Taronga Zoo – Reptile and Amphibian Conservation Centre

State Significant Development SSD 17483577

December 2021

Figure 12 | Southern elevation: EIS (above) and RtS (below) (source: Applicant)

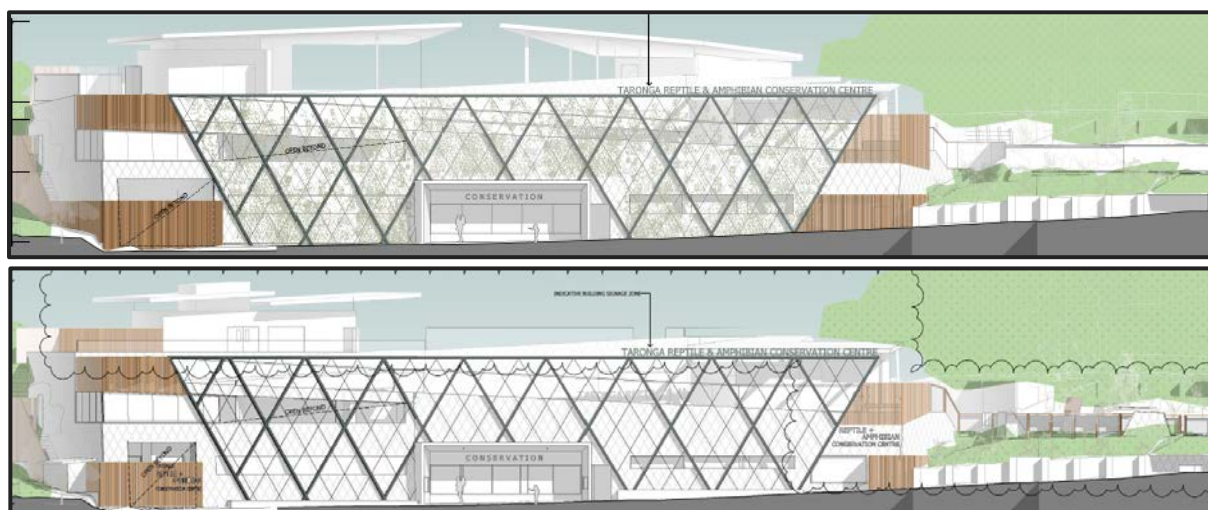
The built form and visual impacts were identified as key issues in public submissions. Concerns were also raised about the potential overdevelopment of Taronga Zoo, including the need for a masterplan to guide future developments.

As part of the RtS, the Applicant submitted revised plans that incorporated amendments to the built form of the proposal. The final design reduced the GFA from 1,264 m² to 1,210 m². While the maximum height of the building has slightly increased by 12 cm (from 12.52 m), the extent of the enclosed area on Level 2 has been substantially reduced from 228.6 m² to 80.6 m².

Figure 24 | Eastern entry to RACC building through the remnants of the 'D-shaped' aviaries (Item 19B) (source: Applicant)

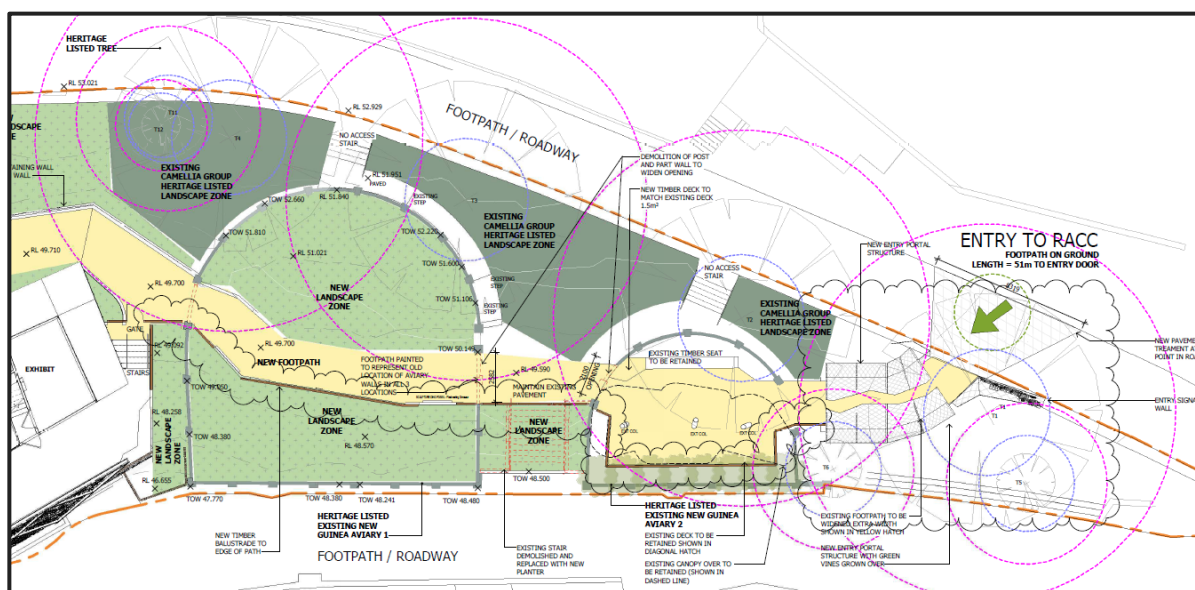
The proposal seeks to construct an on-grade pathway to the RACC building through the aviary structures, which would require the removal of sections of the aviary walls. While resulting in a loss of some fabric, the HIS considered the modification to the aviary walls as preferred to the alternative of constructing a raised ramp structure, as this would be more visually dominant and obscure the aviary layout. The proposed pathway breaches the wall western wall of the larger aviary structure at a point where the aviary wall had been built over a natural sandstone outcrop, which is proposed to be relocated into the Forest Walk landscape design (as discussed in **Section 6.3**). The HIS considered this to have a neutral heritage impact.
